ADMINISTRATIVE APPLICATION CHECKLIST

Applicant: Mesquite SWD, Inc. **OGRID Number:** 161968
Well Name: Scott B SWD #1 **API:** 30-015-44061
Pool: SWD;Devonian - Silver **Pool Code:** 97869

SWD-1642-A

Re: Order No. SWD-1642
API #30-015-44061
Scott B SWD #1

Well Bore Diagram

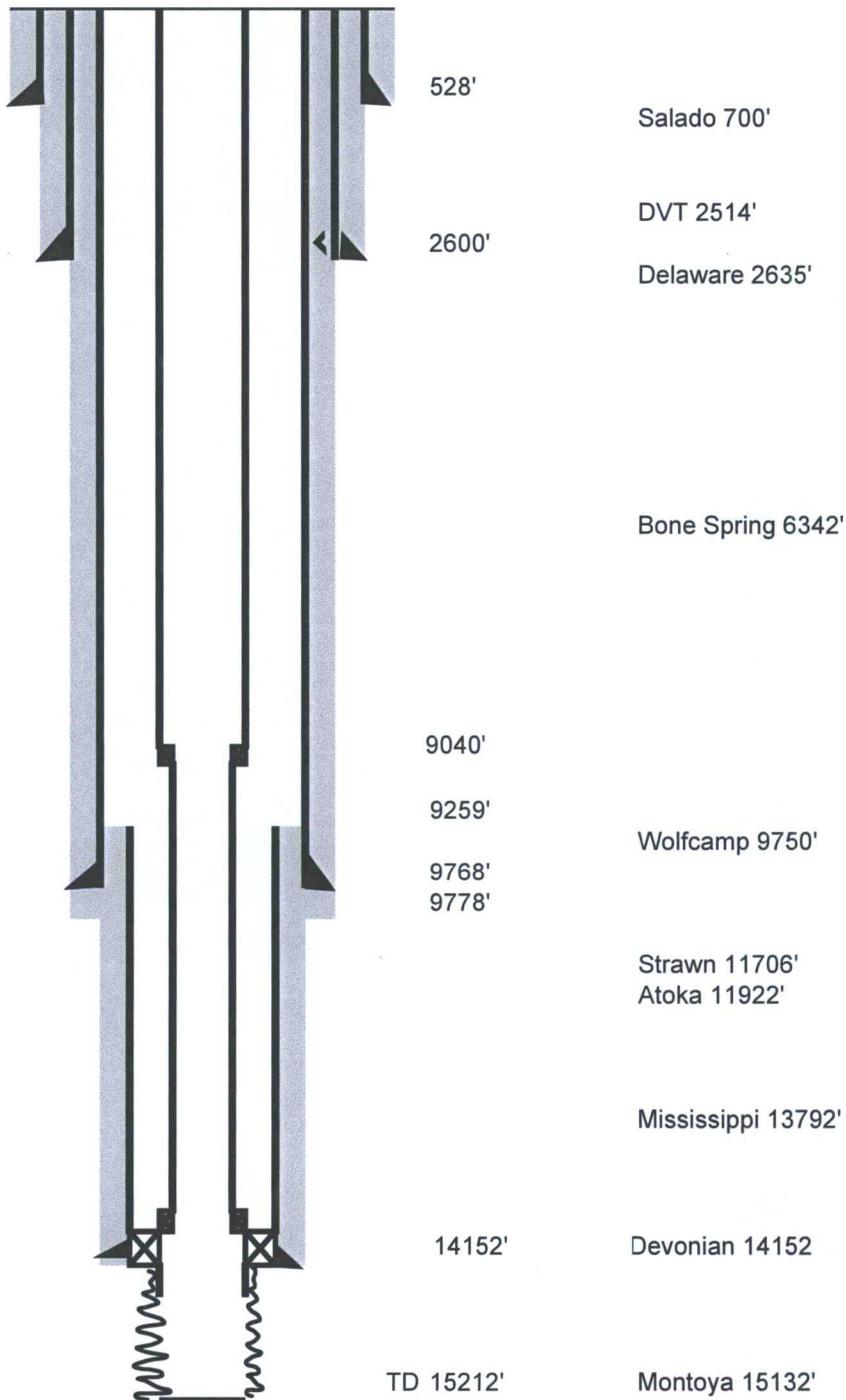
Mesquite SWD, Inc. seeks to amend SWD-1642 which authorizes produced water disposal in the Devonian and Silurian formations through open hole interval 15000 to 16200 feet. We request that this Order be amended to include the Montoya formation in the injection interval with the injection interval being 14152' – 15212'. Attached is a letter from Kay Havenor stating that the Montoya formation will not accept nor yield fluid.

Mesquite SWD, Inc. also requests that SWD-1642 be amended to allow a tapered tubing string, with 5 1/2" tubing inside the surface and intermediate casings and 4 1/2" tubing inside the liner.

WELL LOCATION AND ACREAGE DEDICATION PLAT

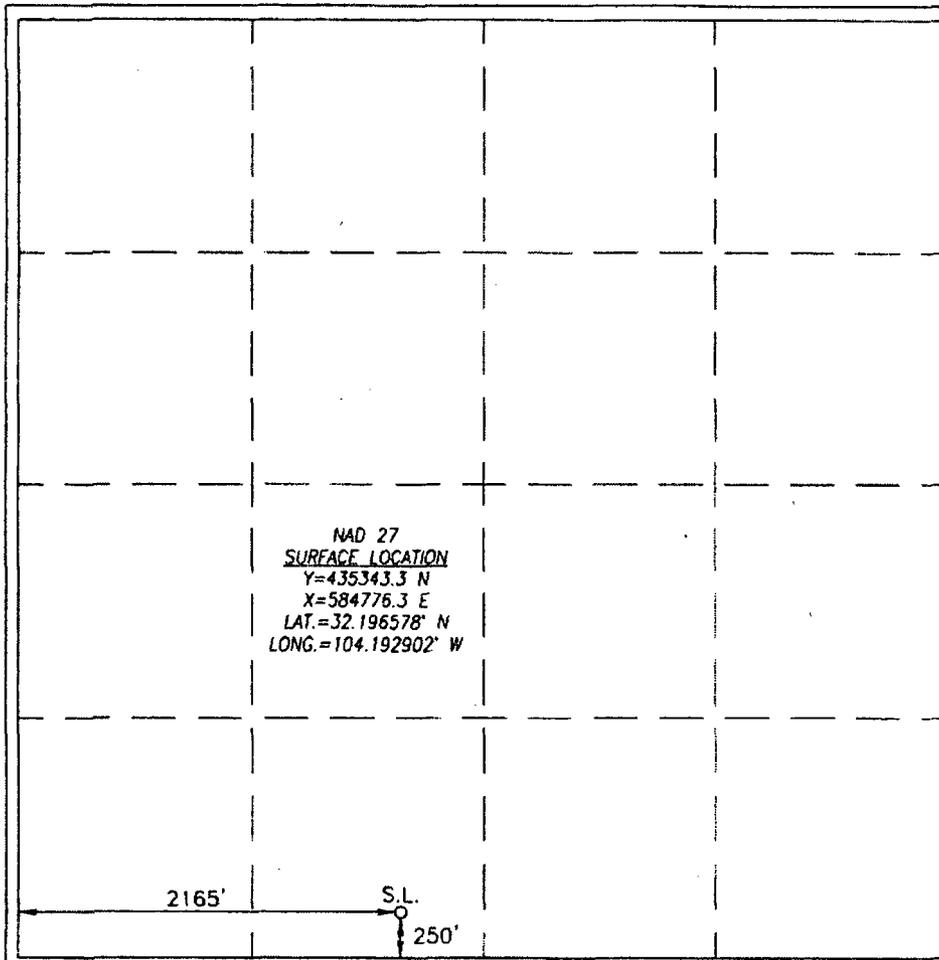
The Mesquite SWD, Inc Scott B SWD-1642 authorized a location of 250' FSL and 2166' FWL of Section 23, T24S-R28E Eddy Co. NM. Due of field conditions, with the surface owners knowledge and consent, the well was positioned 274' FSL and 2165' FWL.

The surface location has changed from the approved permit to the actual location. Proposed surface location 250 FSL and 2166 FWL. Actual location 274 FSL and 2165 FWL, or signed agreement with the surface owner of the changed surface location
Is the surface owner aware of the change? Do you have surface agreement?
I will require a signed statement from Kay Havenor that the ½ mile AOR has not changed.
This issue will have to be resolved before the permit is changed.

This modification does not affect the original AOR.

Please be advised that we, Scott and Valerie Branson, agree with the square footage related to the Scott B SWD well site.
